Service Technical Information

MODEL NO.	AM-HX50 / HX55
SUBJECT	Noise heard on headphones during playback operation

REF.No. :G - A0 - 042 - E0

DATE :29. JUN. 2000

MAIN C.B. mechanism section

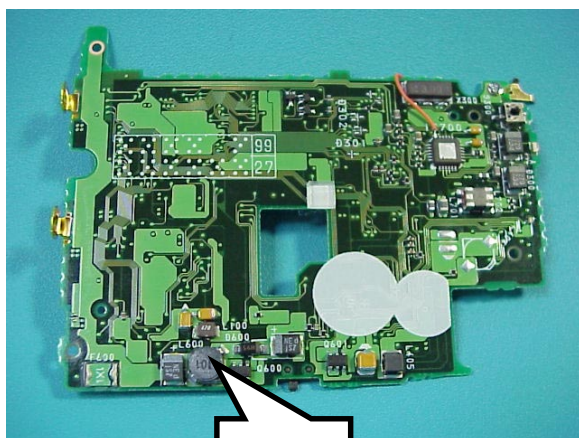
The models concerned may produce low-level noises with volume at minimum position.
The noises occur in synchronization with blinks of OPE LED, approximately 8 seconds after starting playback operation.
Take the following action against the problem.

Change the values from 100 μ H to 180 μ H on L600 in the power supply section.
